EMERGENCY EXPRESS TERMS  
FOR  
PROPOSED BUILDING STANDARDS  
OF THE  
DIVISION OF THE STATE ARCHITECT

REGARDING PROPOSED CHANGES TO  
CALIFORNIA BUILDING CODE  
CALIFORNIA CODE OF REGULATIONS, TITLE 24, PART 2  
ACCESSIBILITY TO PUBLIC BUILDINGS,  
PUBLIC ACCOMMODATIONS, COMMERCIAL BUILDINGS AND  
PUBLICLY FUNDED HOUSING

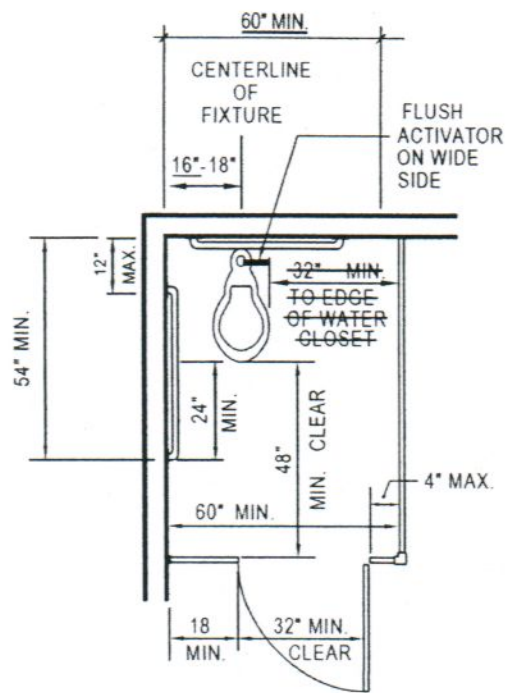
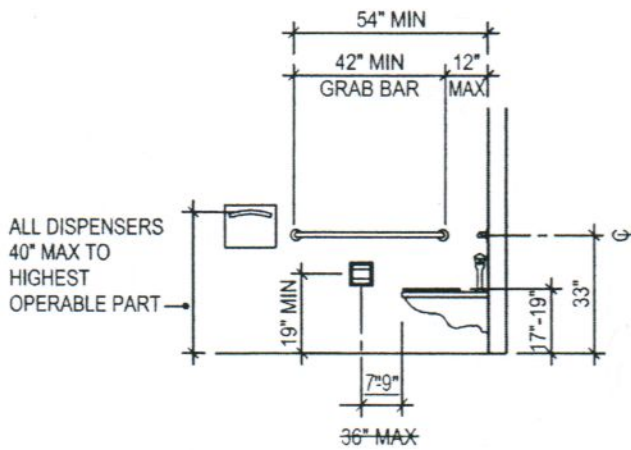
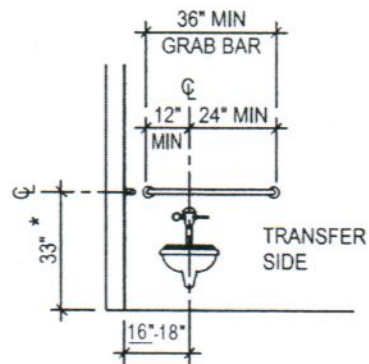
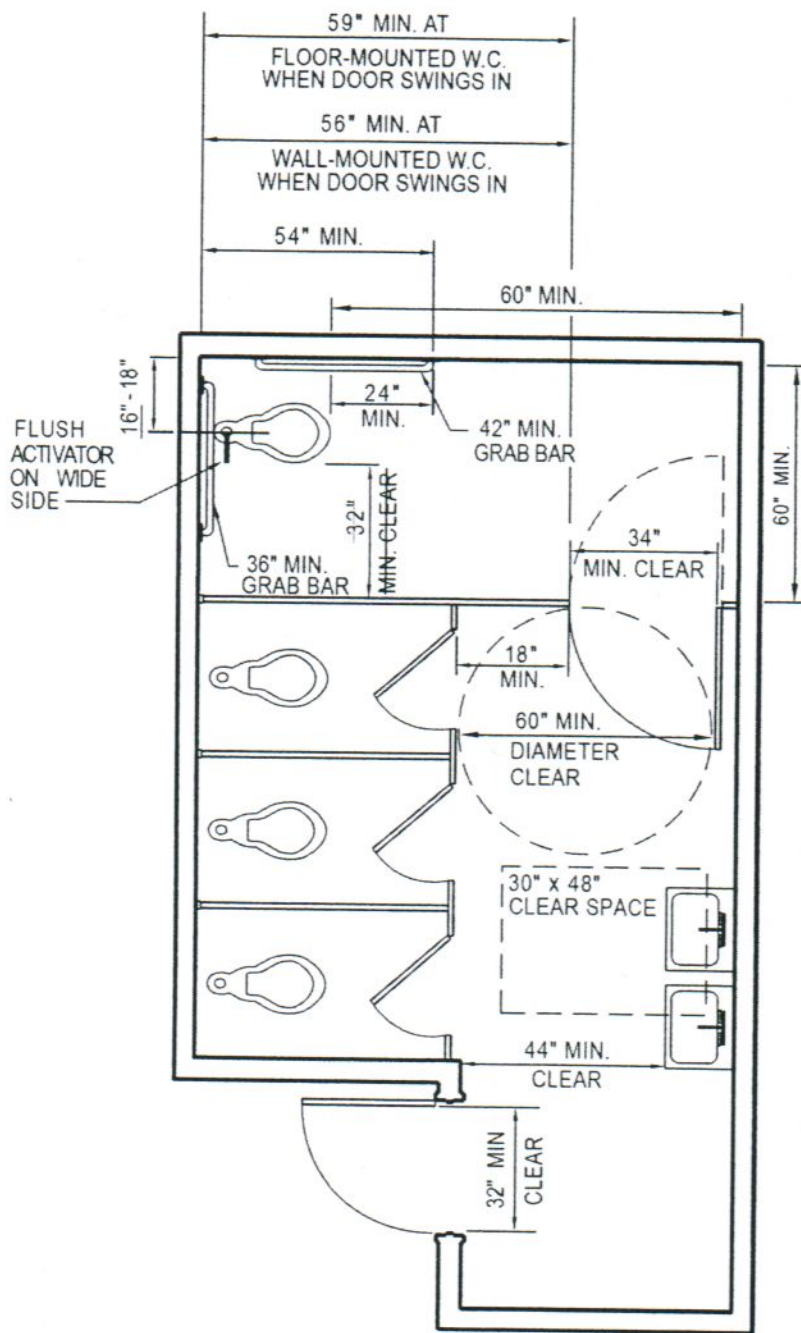
1. *The centerline of the accessible water closet fixture shall be 16 inches (405 mm) minimum and 18 inches (457 mm) maximum from the side wall or partition. ~~On the other side of the water closet, provide a minimum of 28 inches (711 mm) wide clear floor space if the water closet is adjacent to a fixture or a minimum of 32 inches (813 mm) wide clear floor space if the water closet is adjacent to a wall or partition. This clear floor space shall extend from the rear wall to the front of the water closet.~~*

Related code changes are proposed for Figures 11B-1A and 11B-1B for consistency.

**1115B.8.4 Toilet tissue dispensers.** *Toilet tissue dispensers shall be located on the wall within 12 inches (305 mm) of the front edge of the toilet seat, wall or partition closest to the water closet, 7 inches (180 mm) minimum and 9 inches (230 mm) maximum in front of the water closet measured to the centerline of the dispenser, mounted below the grab bar, with the outlet of the dispenser at a minimum height of 19 inches (485 mm), and 36 inches (914 mm) maximum to the far edge from the rear wall. Dispensers that control delivery or that do not permit continuous paper flow shall not be used. See Figure 11B-1A.*

**Statement of Reason:** DSA-AC is proposing to amend this section to align the CBC with the 2010 ADA Standards, Section 604.7. The CBC currently requires toilet tissue dispensers to be located in accessible water closet compartments within 12 inches of the front edge of the toilet seat and within 36 inches of the rear wall. The amendment to this section will require the centerline of the toilet tissue dispenser to be within a range of 7-9 inches in front of the water closet. Additionally, language consistent with the 2010 ADA Standards, Section 604.7 is being added to clarify the regulated height of the toilet paper dispenser is measured to the outlet of the dispenser.

FIGURE 11B-3A - DRINKING FOUNTAINS

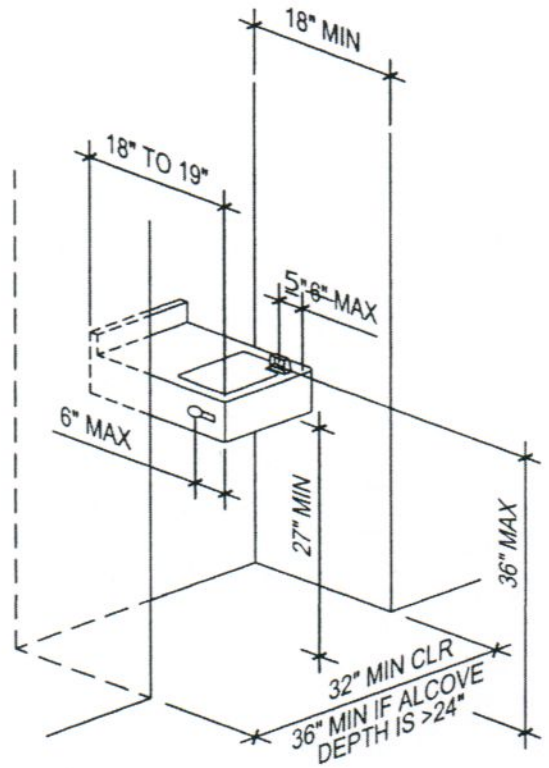
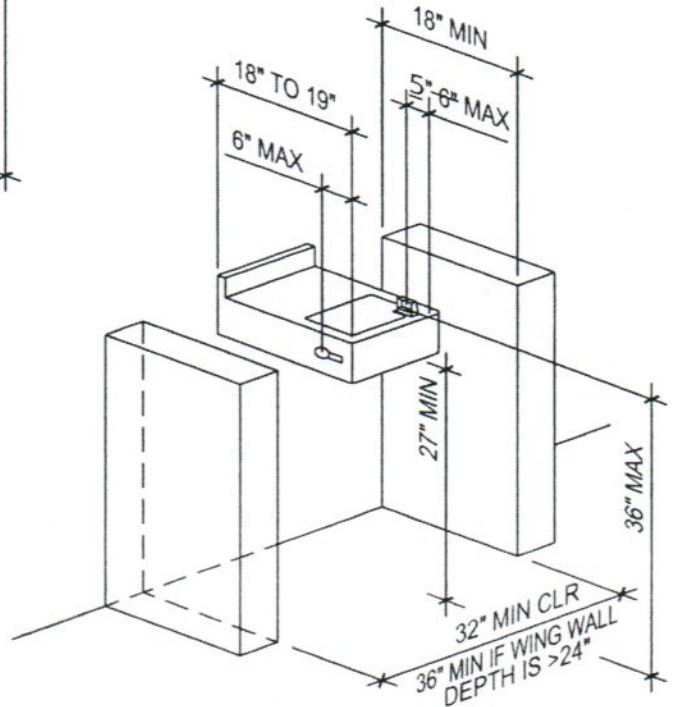
CBC Section 1117B.1, Item 4 is being amended to incorporate language from 2010 ADA Standards Section 602.4 which requires the drinking fountain spout to be located 15 inches minimum from the vertical support and 5 inches maximum from the front edge of the unit, including bumpers. A title for this section is also being added.

CBC Section 1117B.1, Item 5 is being amended to incorporate federal language which requires a water flow location of 5 inches maximum from the front of the unit. Language is also being added to describe acceptable angles of water flow, relative to the front of the drinking fountain, based on varying spout locations as measured from the front of the unit. A title for this section is also being added.

A related code change is proposed for Figure 11B-3A for consistency.
